TECHNICAL NOTE

Date: 7th December 2018

Project: Cinders Farm – Traffic and Transport Matters

- 1.1 This Technical Note (TN) has been produced by SK Transport Planning Limited in response to Wrexham Council's traffic and transport comments on Planning Application P/2018/0577 relating to the erection of four agricultural buildings and plant, associated infrastructure, landscape and access arrangements. The development proposes to deliver a new poultry farm scheme at the farm, as part of a farm diversification programme.
- 1.2 The Council's formal traffic and transport comments issued on the 28th August 2018 are appended to this letter for information in **appendix a**. In addition, a site visit with the Council's Highways Officer took place on the 8th October 2018.
- 1.3 The development proposals were also subject to pre-application discussions, and at the time the Council's Highways Officer commented as follows:

SK21685-10 REV A

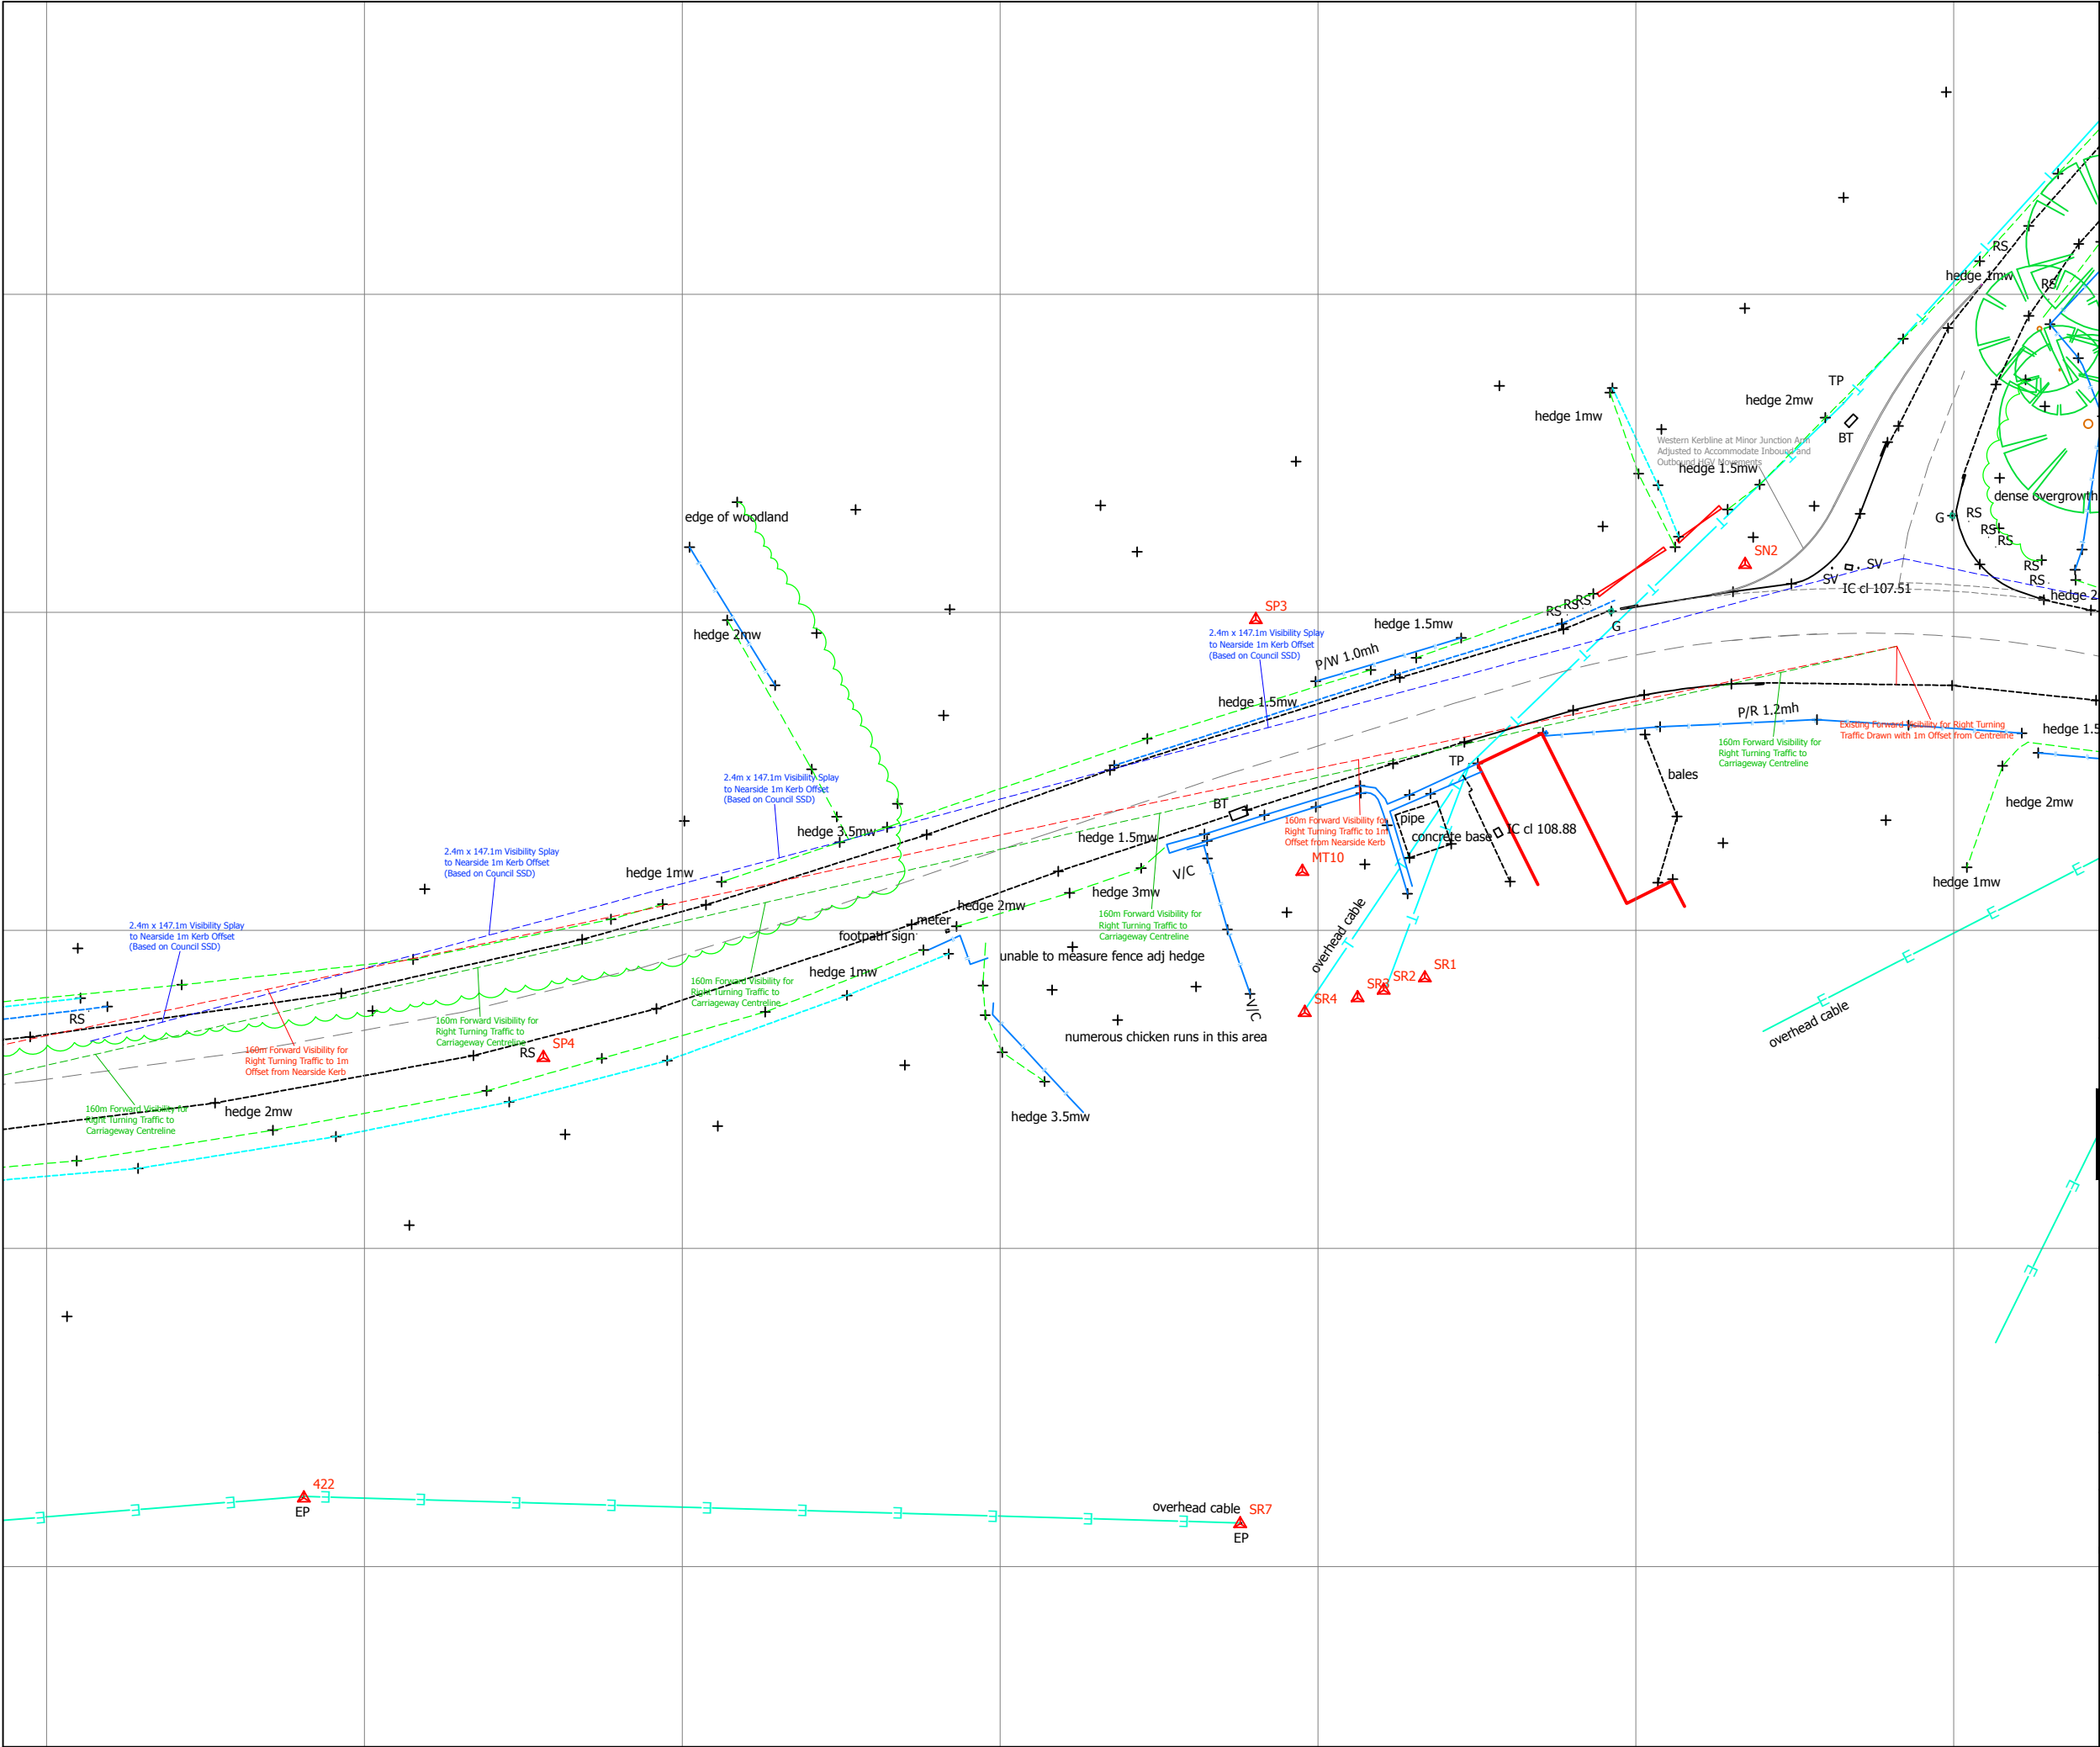
Visibility from the existing junction onto the A539 is currently inadequate in both directions. Visibility in the westerly direction is approximately 2.4 x 120m measured to the nearside edge of the adjoining highway. Visibility is impeded by the existing hedgerow and I assume any improvements would require work on 3rd party land. Visibility in the easterly direction is inadequate providing a splay of approximately 2.4 x 30m measured to the nearside edge of the adjoining highway. Visibility is impeded by the existing hedgerow along this section. I understand that the applicant is offering to improve visibility in this direction and provide a splay of 2.4 x 120m measured to the nearside edge of the adjoining highway. I assume that the applicant has control of this land in order to deliver this improvement.

Any proposed junction in this location would also normally be required to provide adequate forward visibility between vehicles waiting to turn into Cinders Lane and vehicles approaching from the west providing a stopping sight distance (SSD) of 160m. Forward visibility in this location is approximately 90m being impeded by the existing building on the bend belonging to Wynnstay Stables.

Forward visibility splays have not been indicated on the submitted layout plan. **I would recommend that the applicant provides this information on a revised layout plan.**

- 1.15 These visibility splays have been overlaid onto a topographical survey, as suggested by the Council's Highways Officer at the site meeting. The splays have been drawn with a 2.4m "X" distance setback and the "Y" distances as presented above. The splays have been drawn with a 1m offset from the nearside kerb, to deliver appropriate intervisibility between a vehicle waiting on the minor junction arm and a vehicle approaching from the eastern and western traffic direction. The drawings are presented in **appendix c**.
- 1.16 The drawings confirm that with management of the hedges on either side of the minor junction arm it is possible to deliver these visibility splays in perpetuity. The splays are confirmed to cross land the applicant controls or the publicly adopted highway, and offer a material betterment for all

- 1.17 The Council has also requested an assessment of the achievable forward visibility for vehicular traffic turning right from the A539 into the existing rural lane that is used to access Cinders Farm. The drawings presented in **appendix c** confirm that using a 1m offset from the carriageway centreline to reflect the position of a motorist in a vehicle turning right into the minor junction arm it is possible to achieve 160m forward visibility.

SK21685-05 REV A

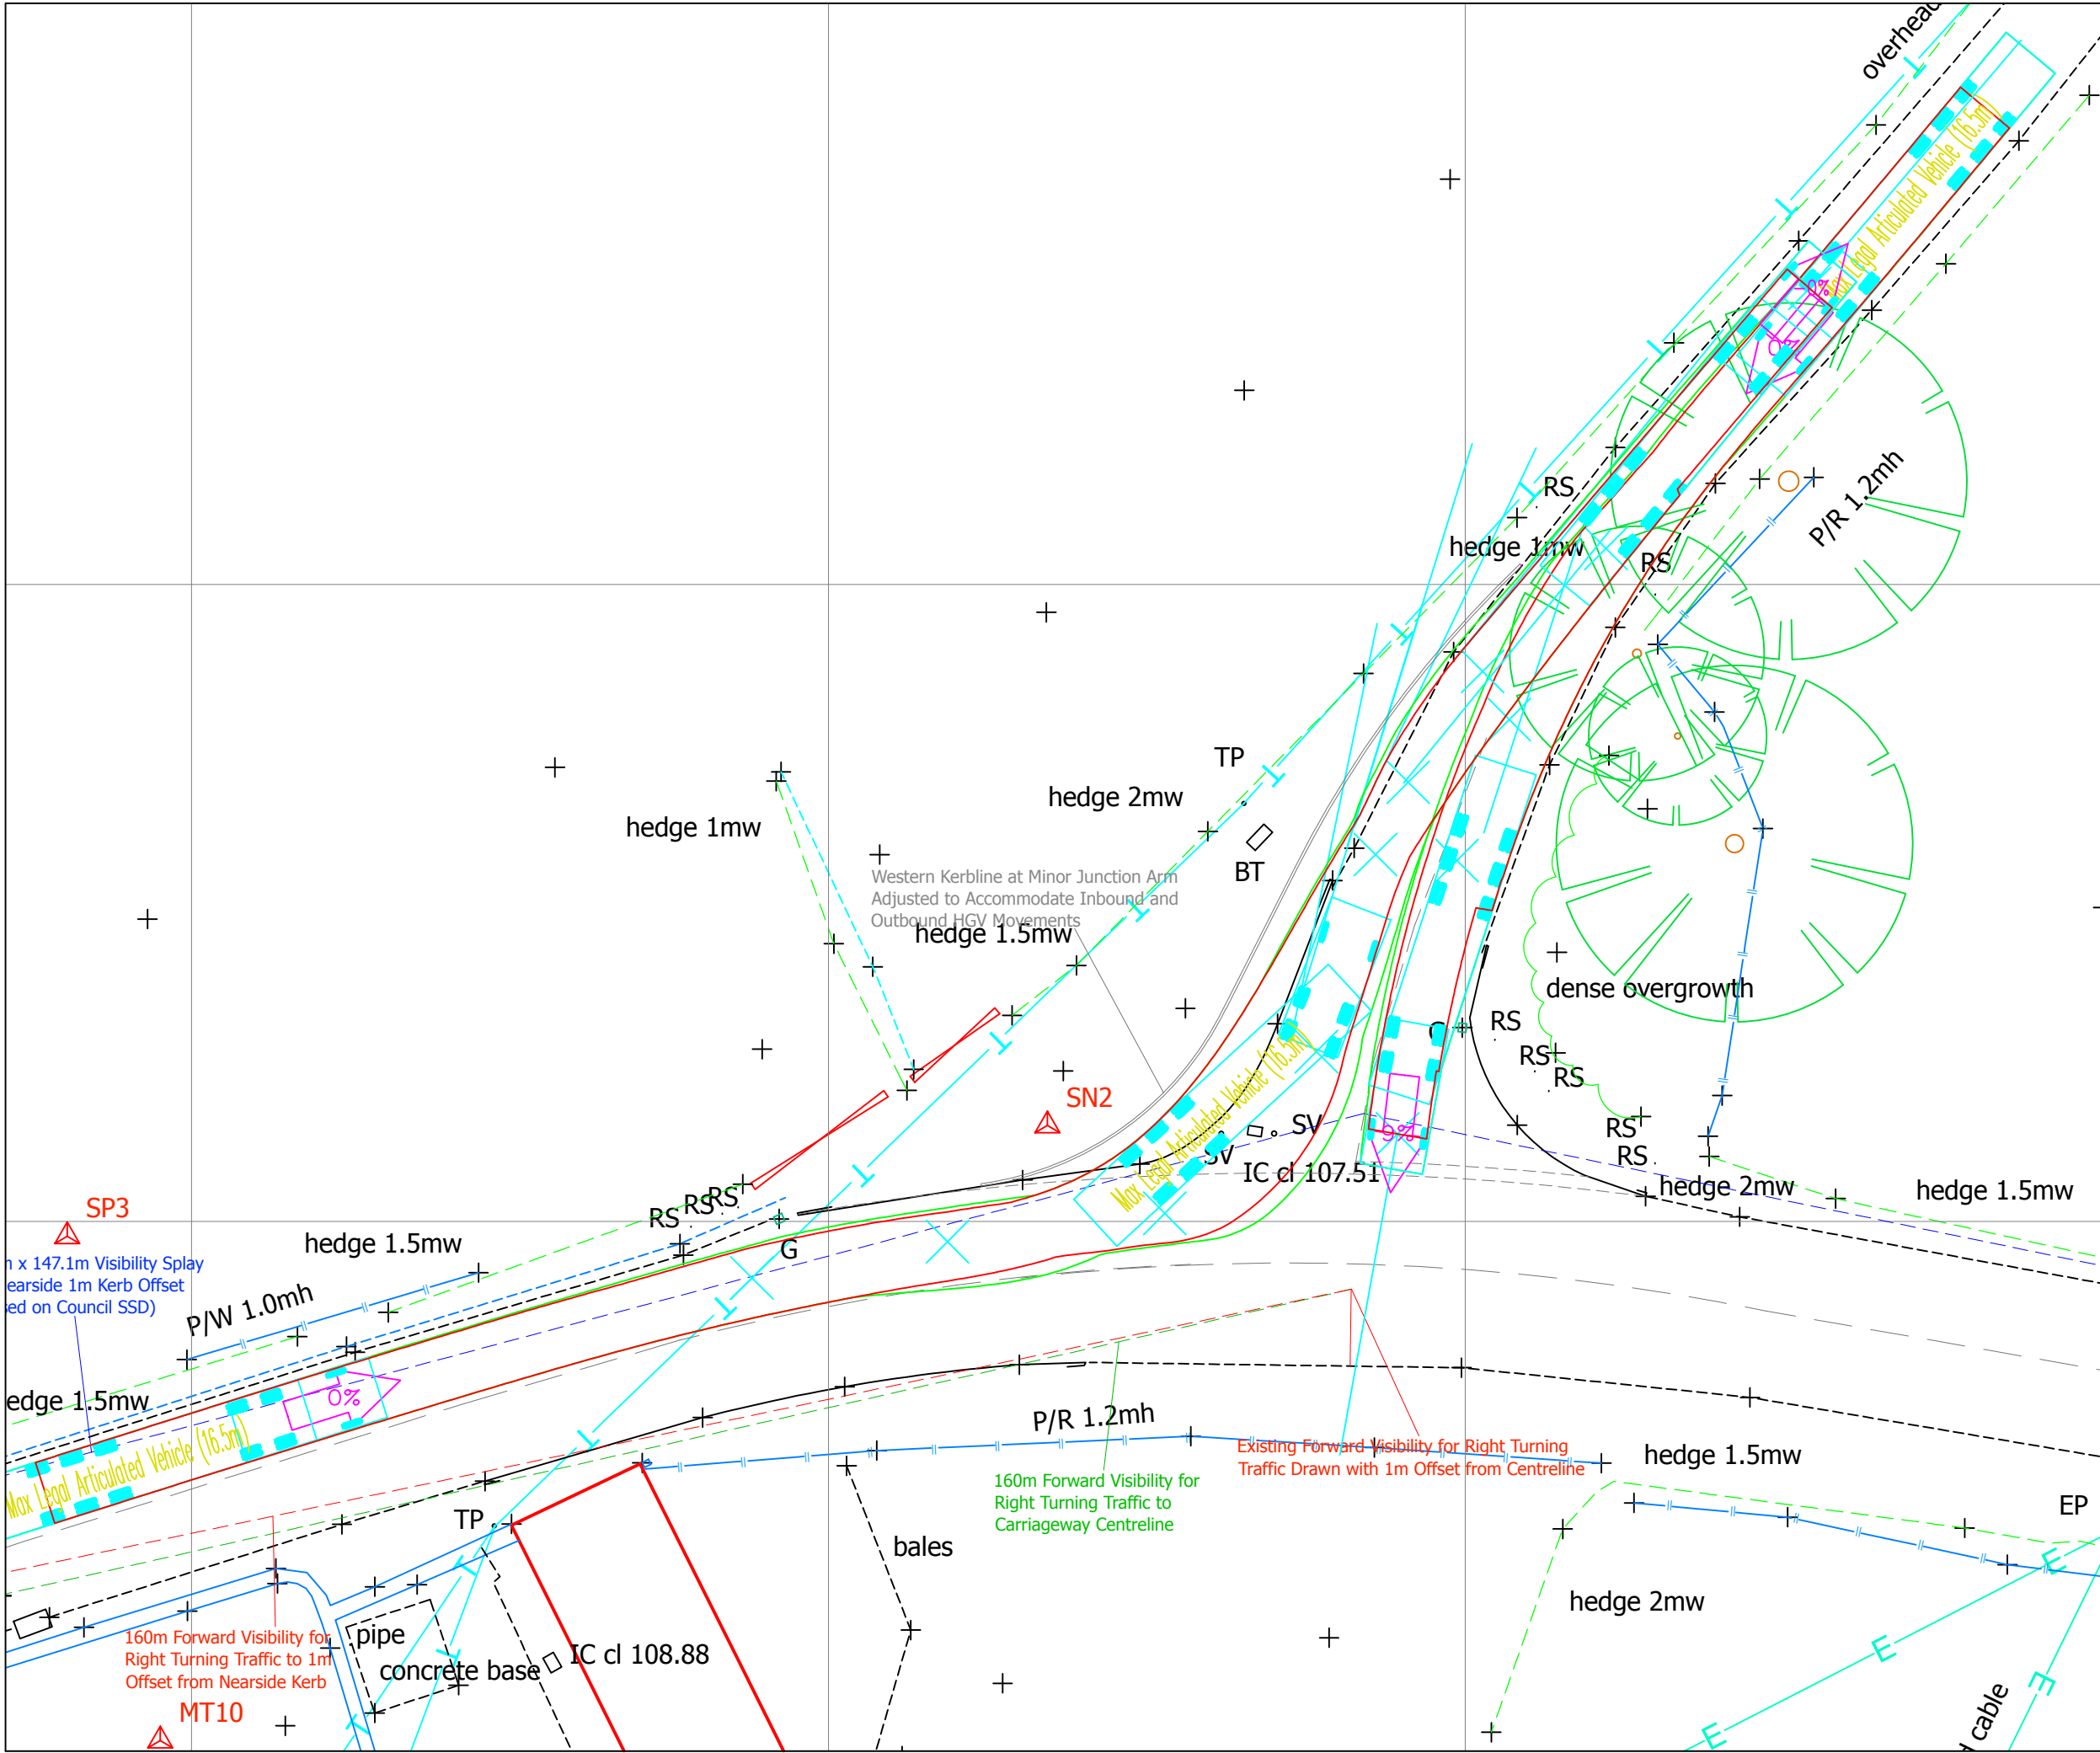
However, I would recommend the submission of a suitable layout plan indicating specific parking and turning arrangements of cars / HGVs within the curtilage of the site. Appropriate swept path details will need to be submitted demonstrating how HGVs (16.5m long) will enter / park / turn / exit the site. Details of maximum number of vehicles likely to be on site at any one time and where they will park will need to be provided.

Swept path details will need to be provided at the A539 / Cinders Lane junction (all directions) and at the proposed access to the site (in and out) off Cinders Lane.

- 1.22 Turning to the access to the development, the proposed site access has been tracked to demonstrate that it can accommodate a 16.5m maximum legal articulated vehicle without overrunning verges. The swept path analysis is provided in **appendix f**. The design team has noted the Council's comments that as part of these access works there will be a need to culvert the existing open ditch to form the new access.
